Architect's Supplemental Instructions

Architect's ASI No: 036

Project:
Webster University
Interdisciplinary Science
Building

Discipline Code: 03 Electrical

E0103.A

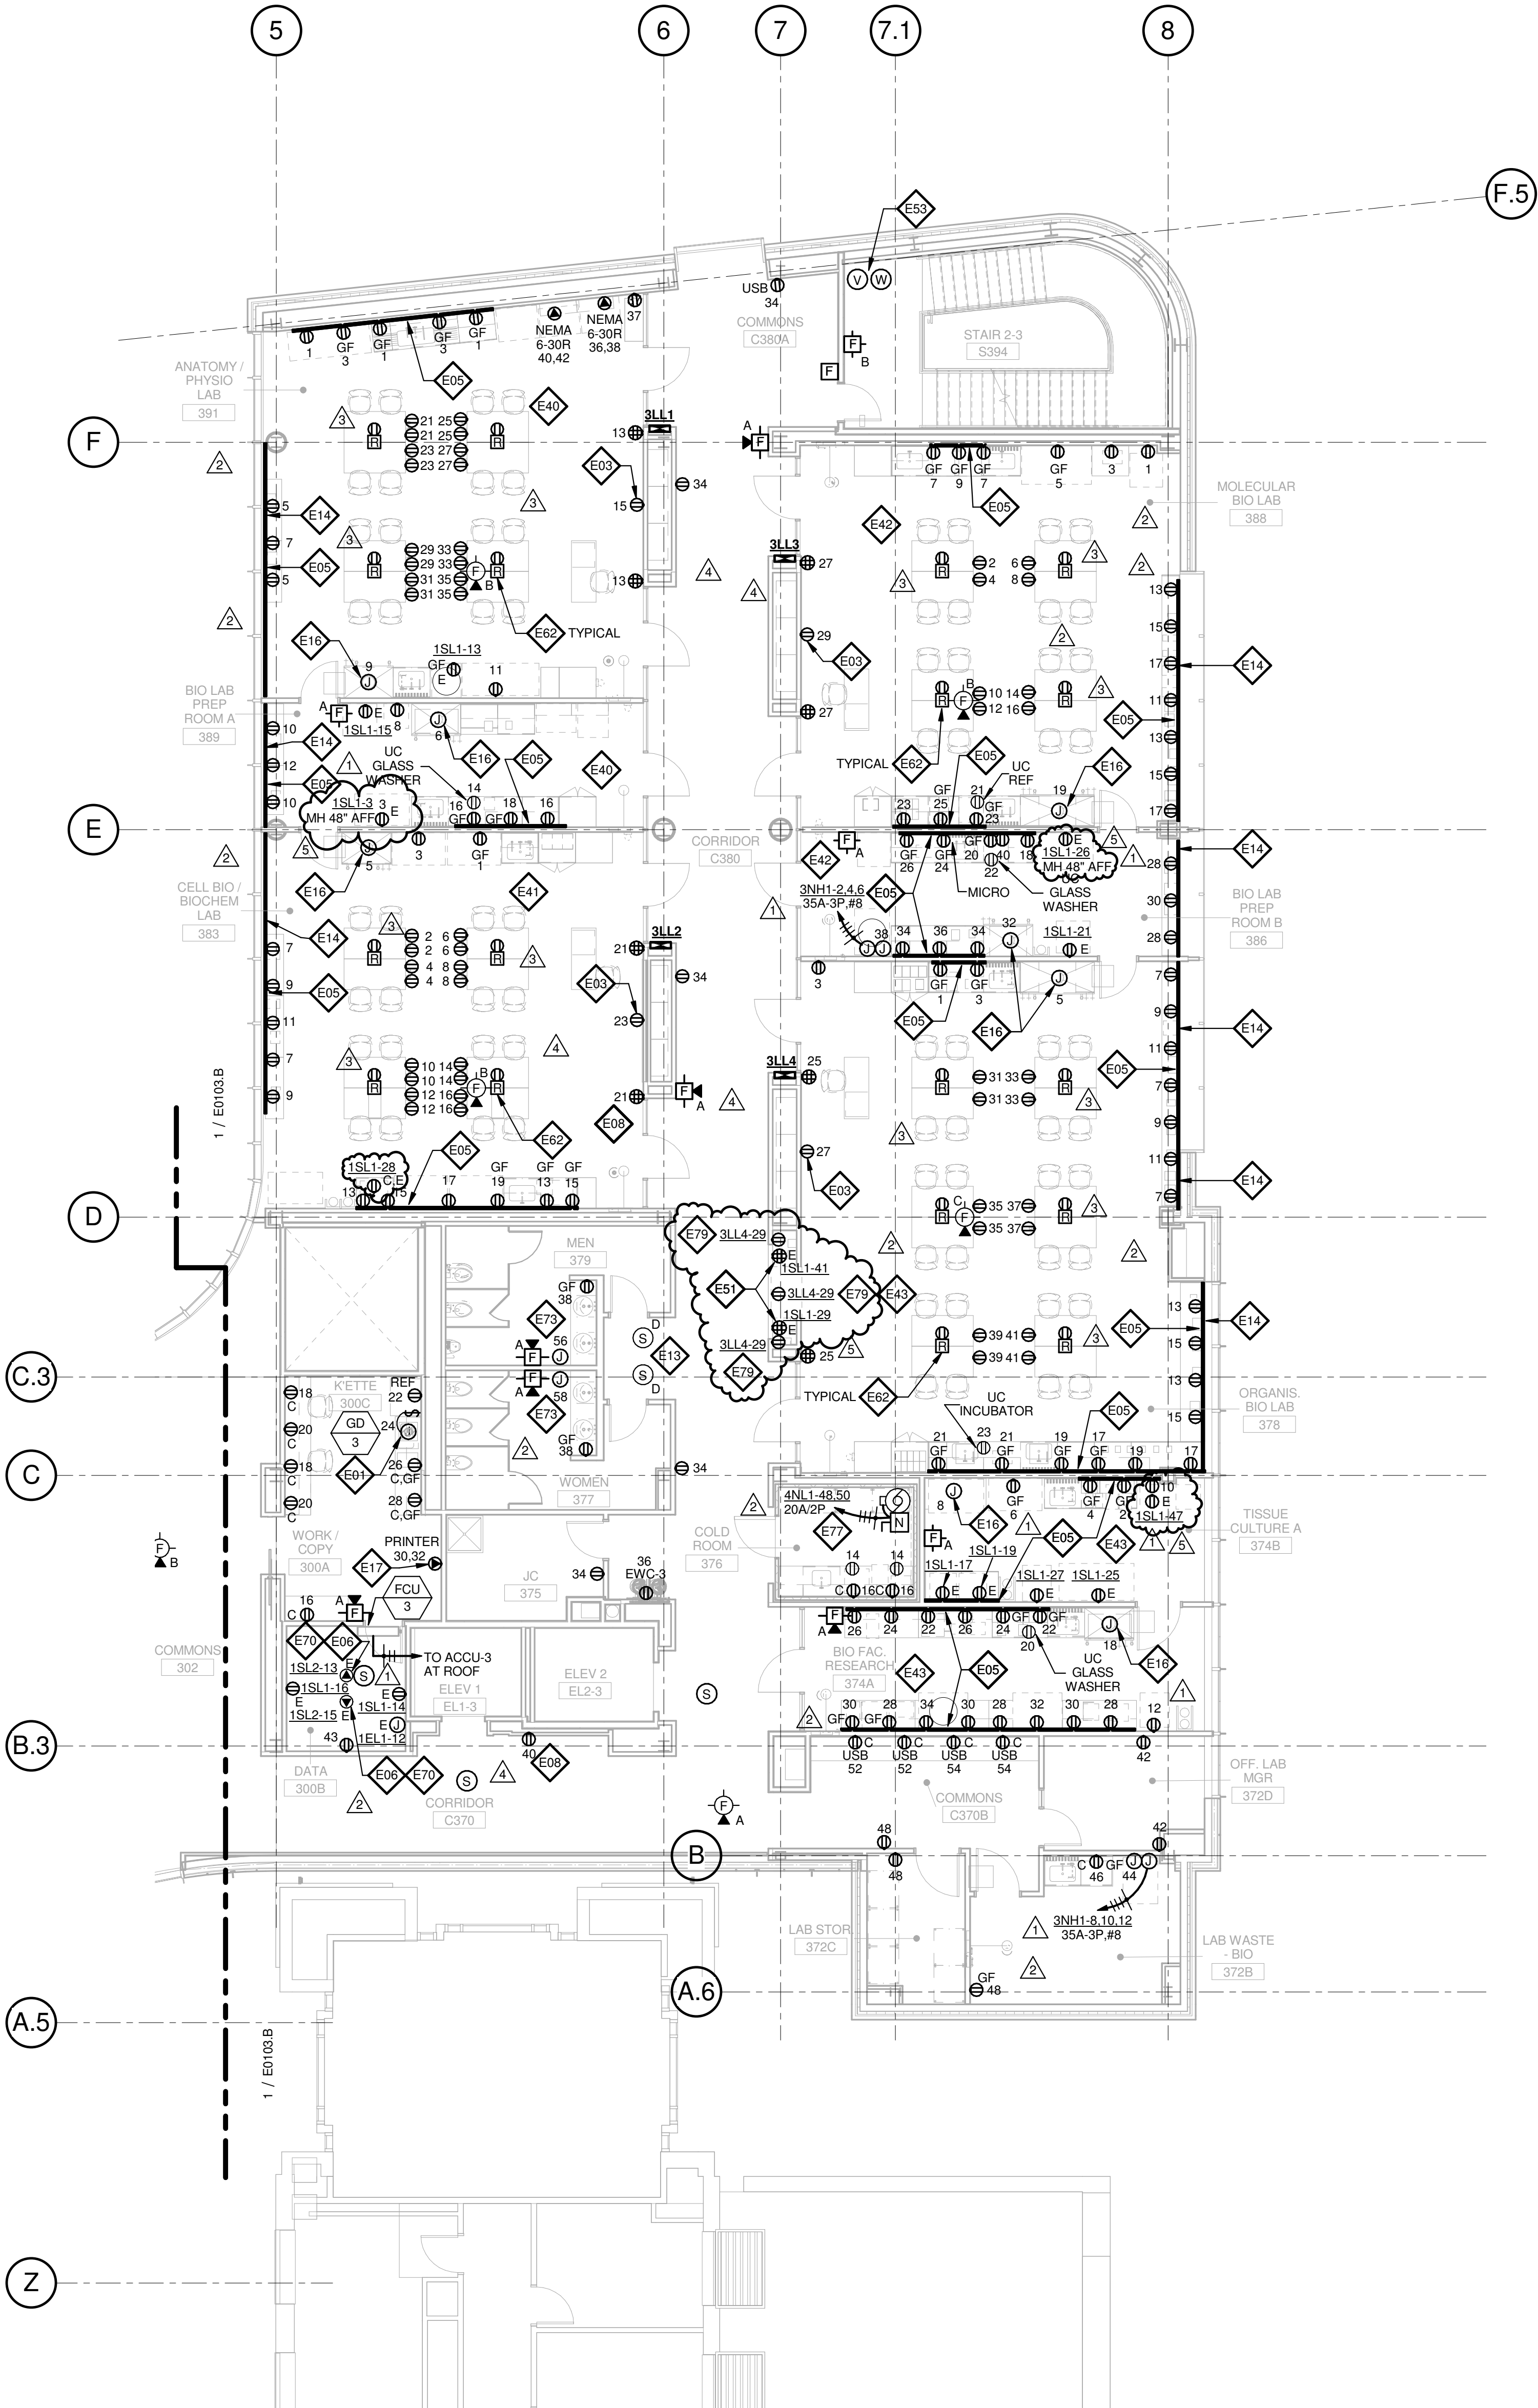
SHEET E0103.A LEVEL 03 AREA A FLOOR PLAN – ELECTRICAL

- In room 389, connect deli cabinet to emergency power circuit 1SL1-3. Delete circuit 20 previously serving equipment.
- In room 383, provide emergency power for incubator and connect to circuit 1SL1-28.
- In room 374B, provide emergency power for refrigerator and connect to circuit 1SL1-47.
- Add Keyed Note E79 to notes list, for aquarium lights.
- In room 378, revise location of emergency aquarium quad receptacles and add three ceiling mounted duplex receptacles for aquarium lights.

E0103.B

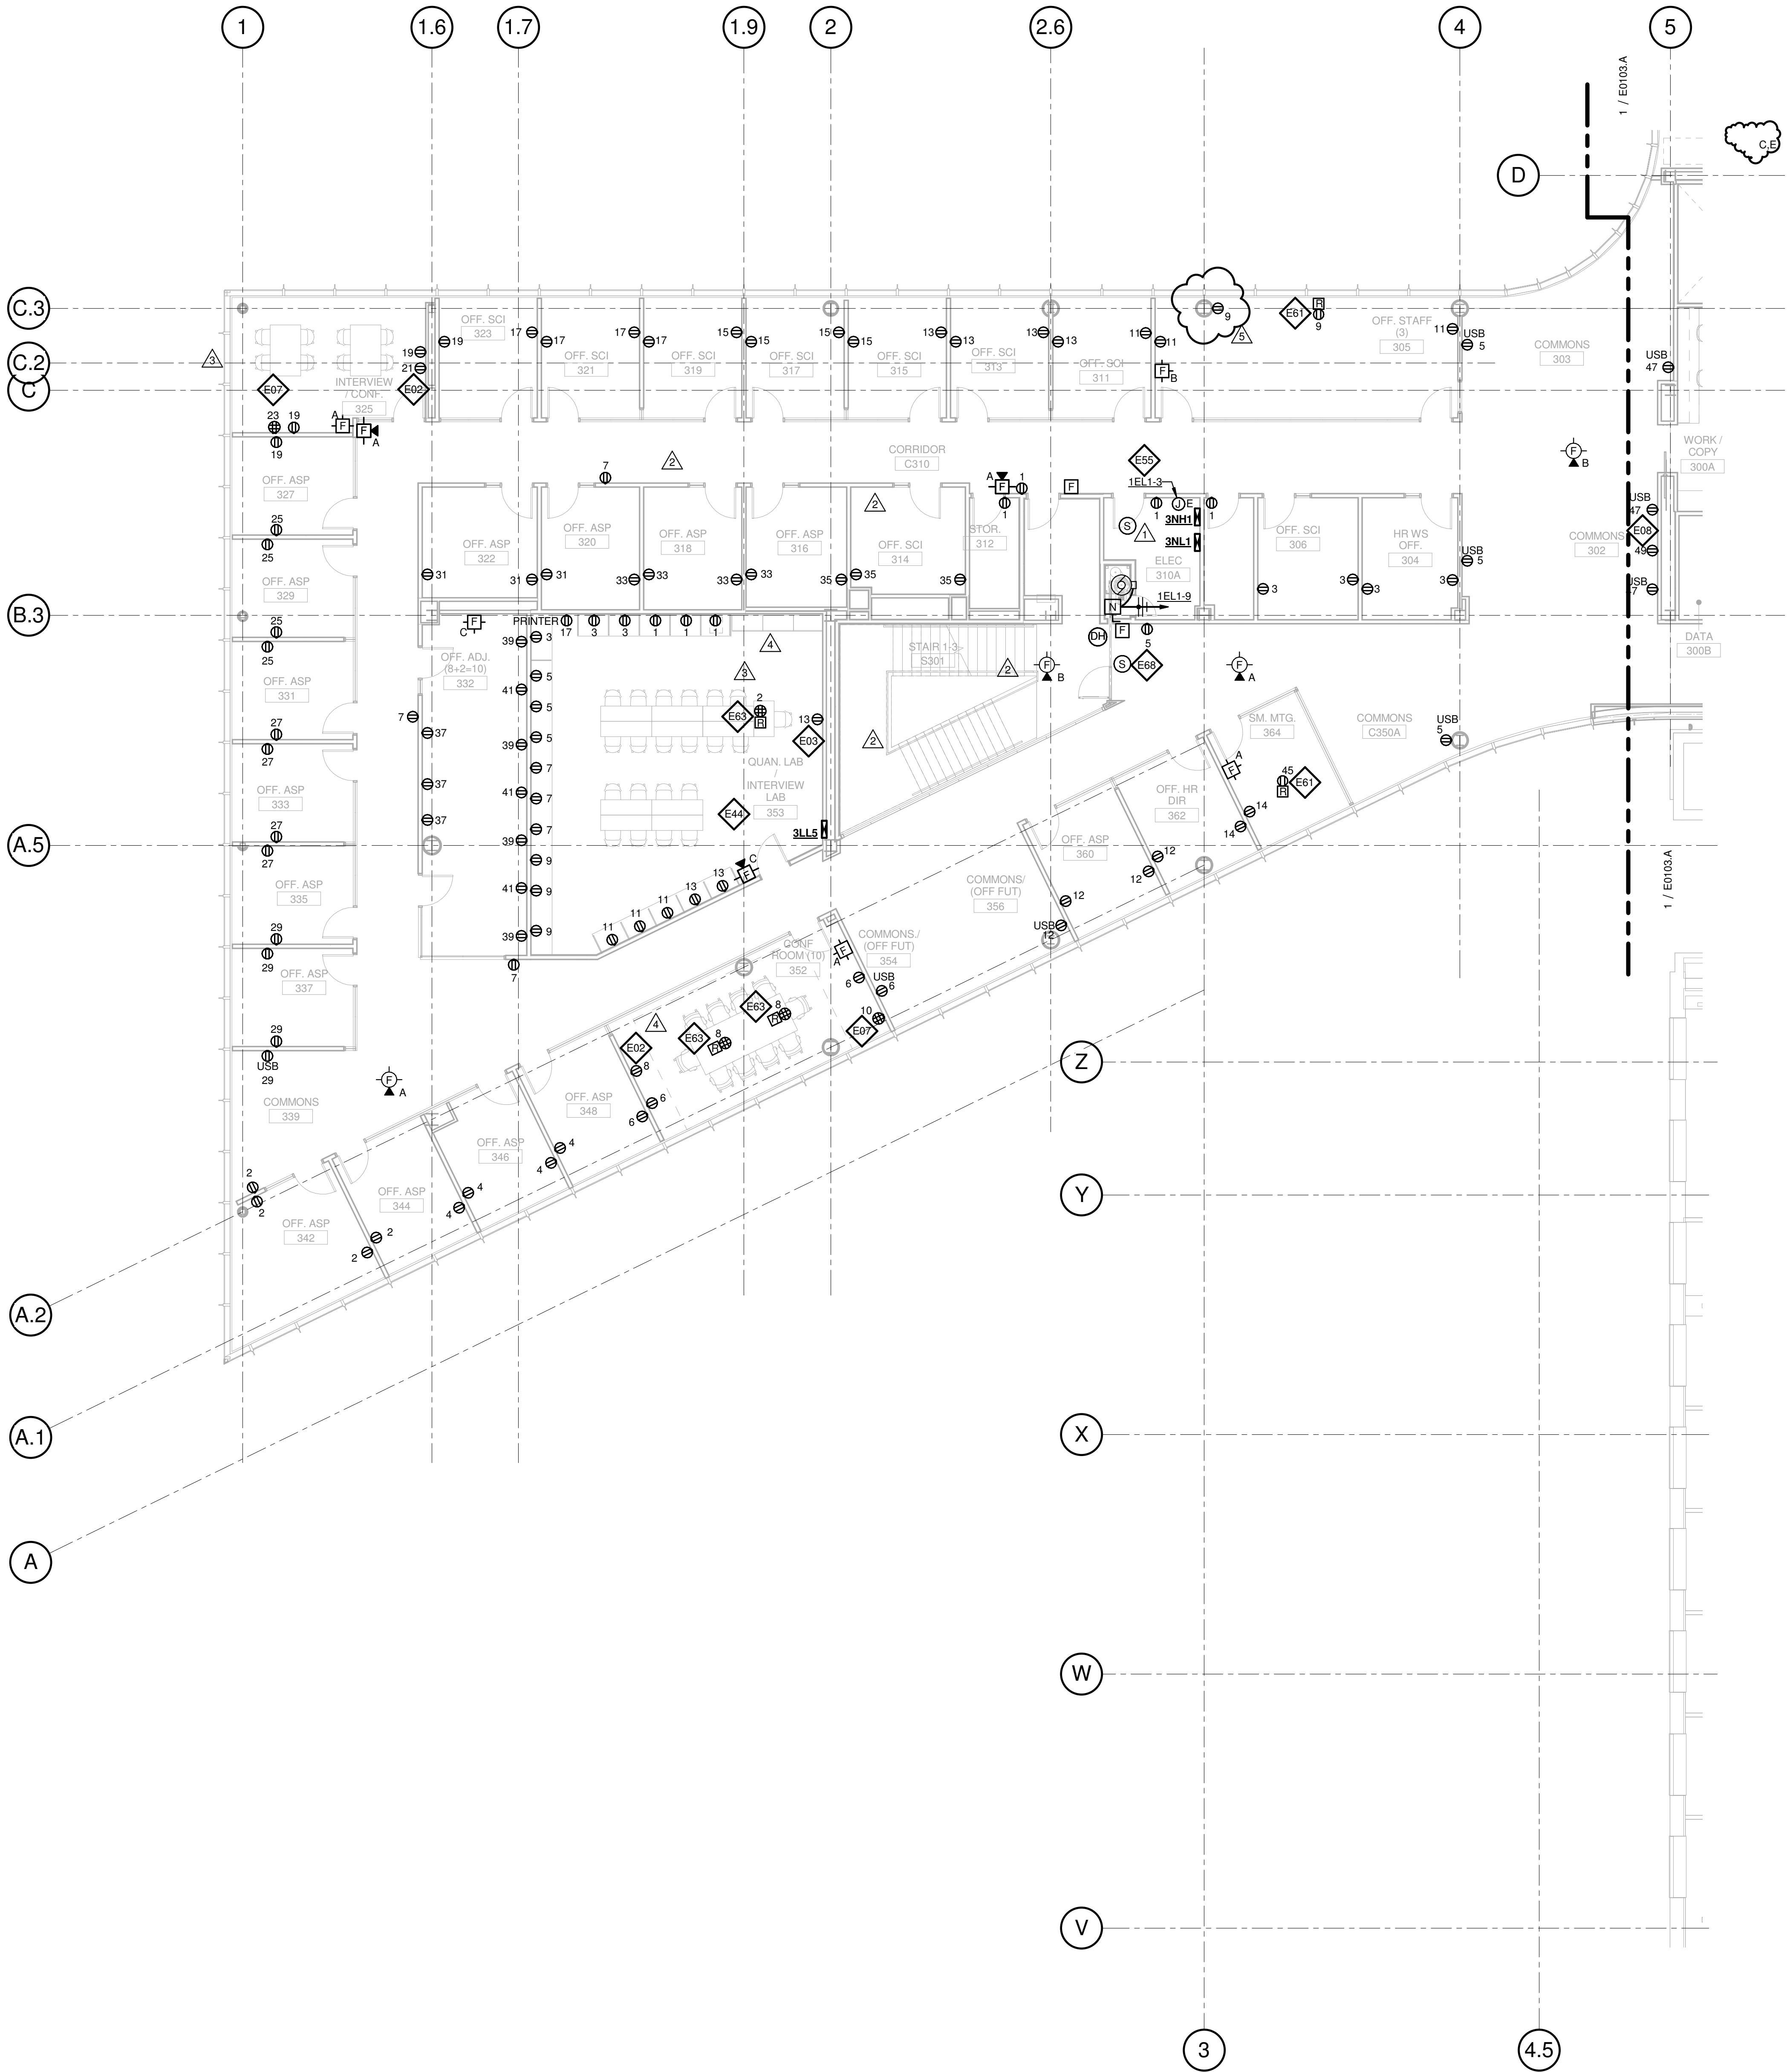
SHEET E0103.B LEVEL 03 AREA B FLOOR PLAN – ELECTRICAL

- In room 305, provide column mounted duplex receptacle.

E0104.A

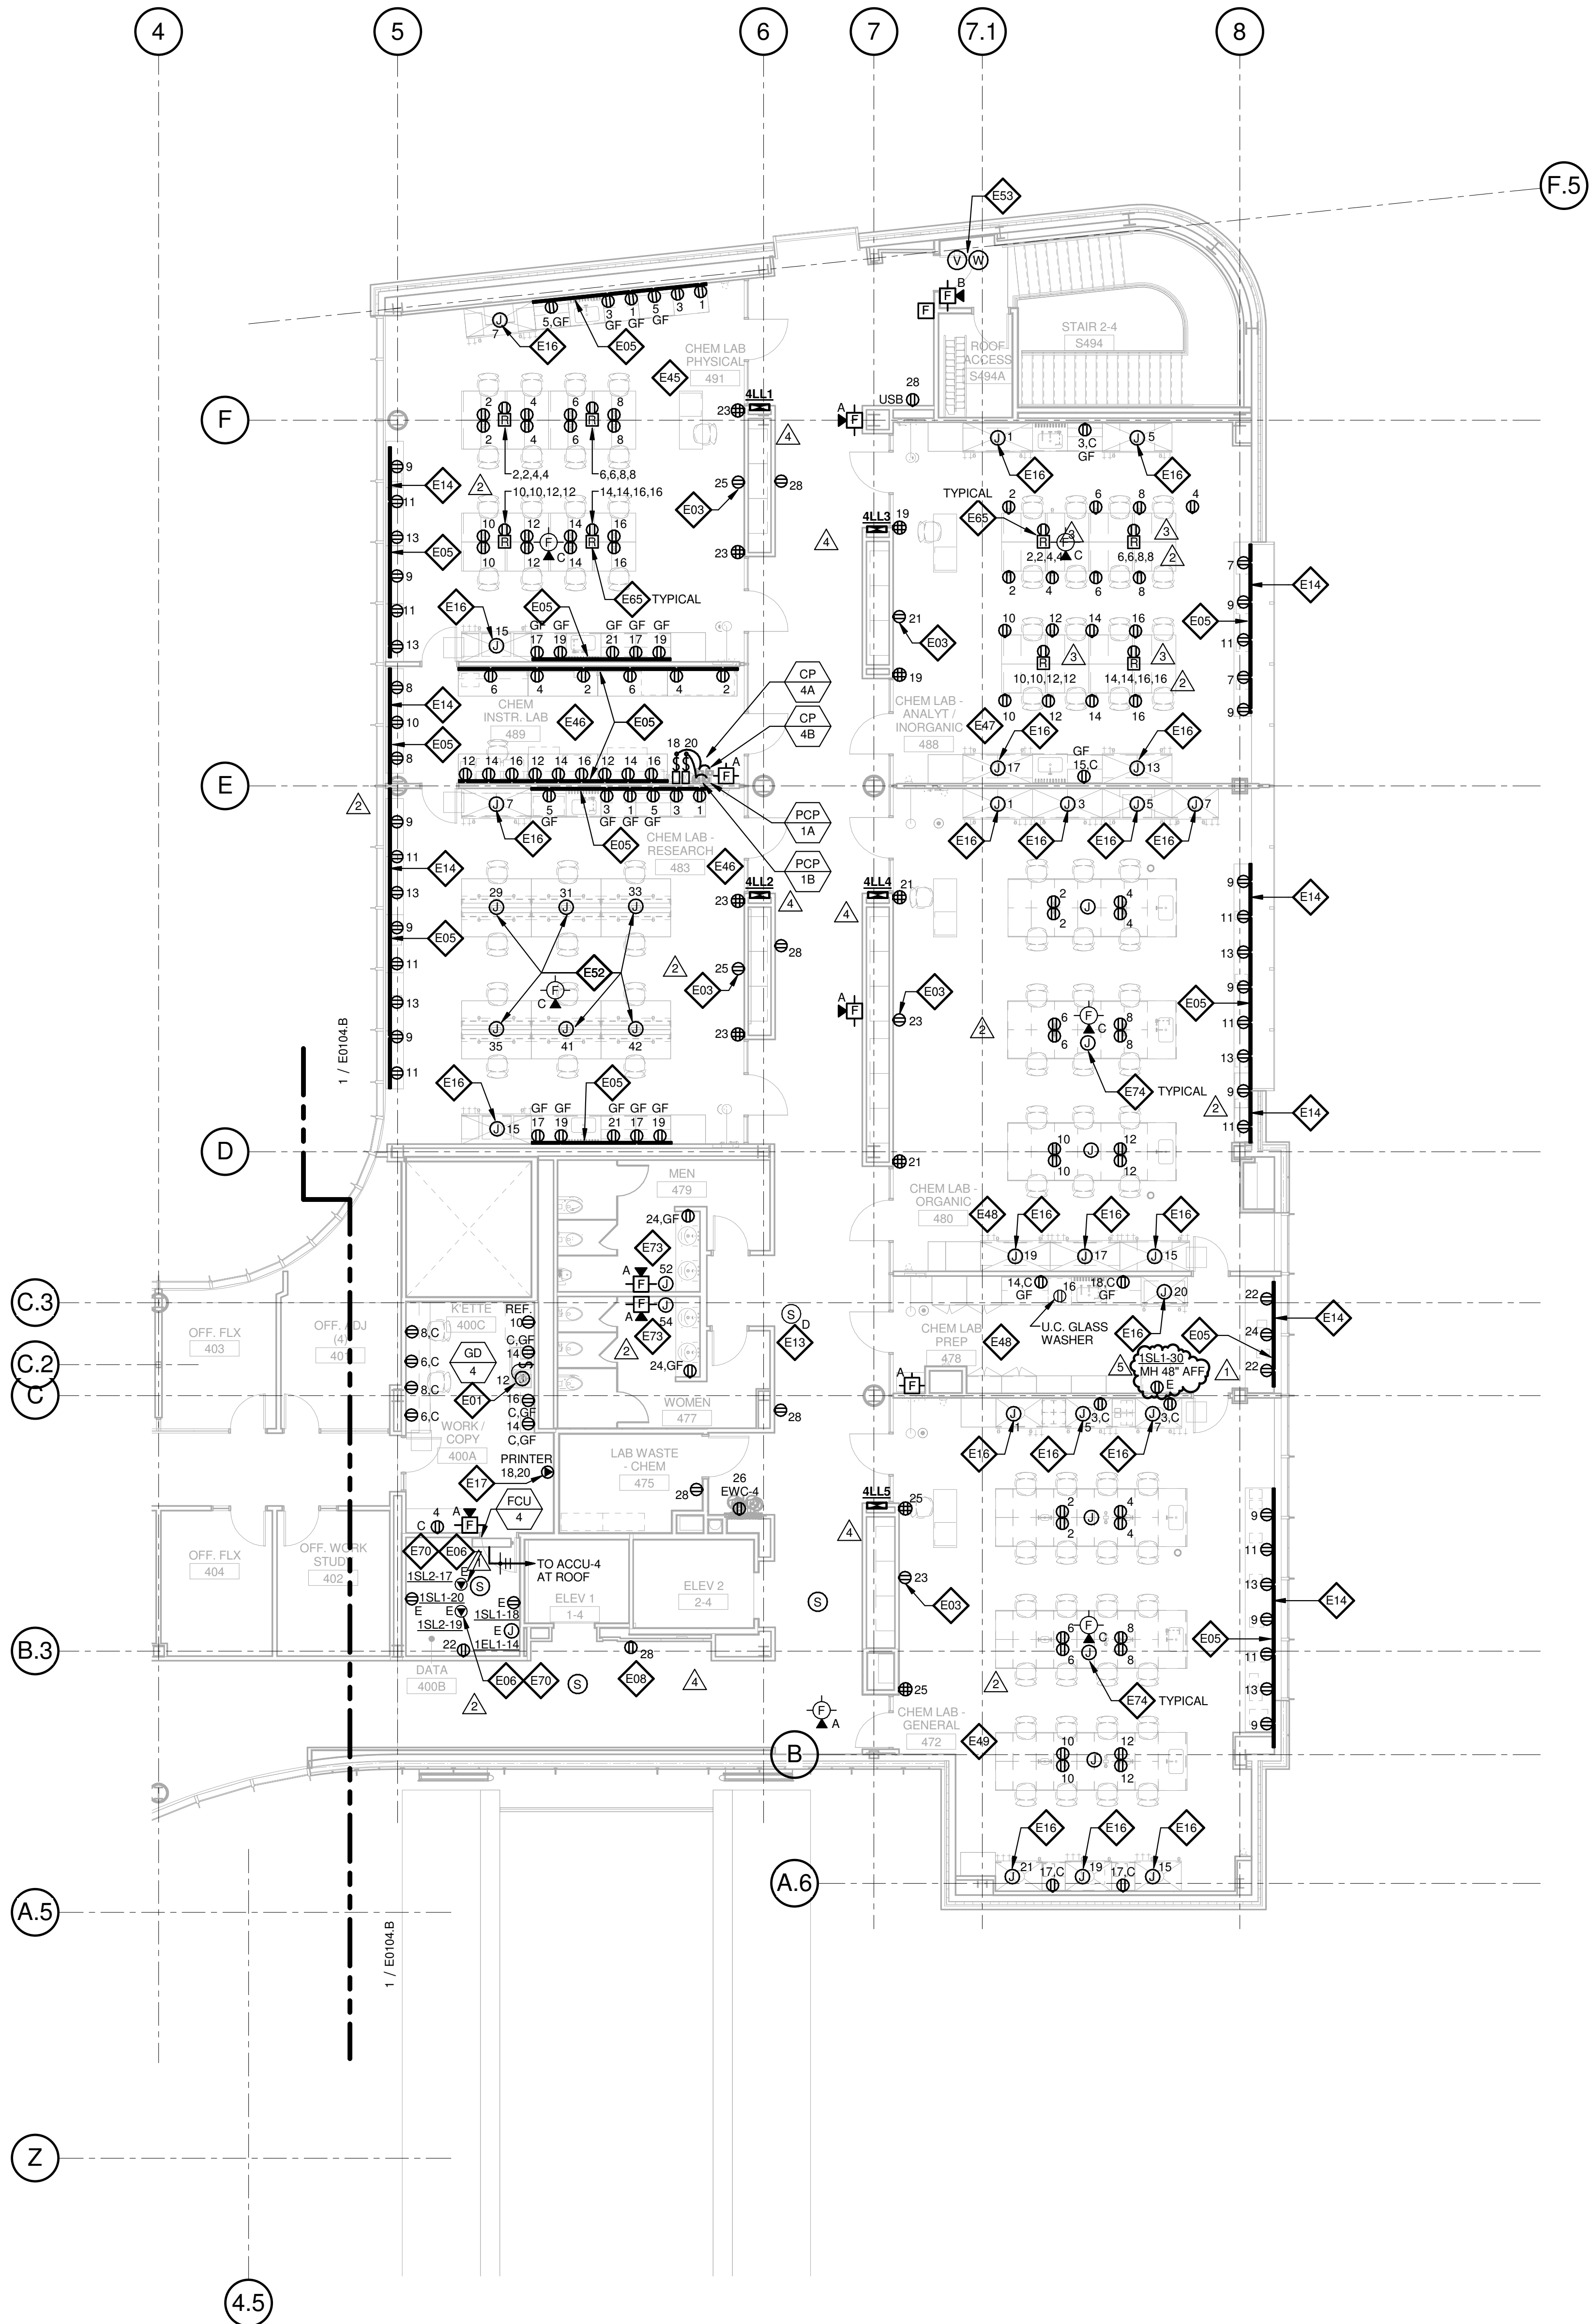
SHEET E0104.A LEVEL 04 AREA A FLOOR PLAN – ELECTRICAL

- In room 478, connect refrigerator to emergency power circuit 1SL1-30. Delete branch circuit 26 previously serving equipment.
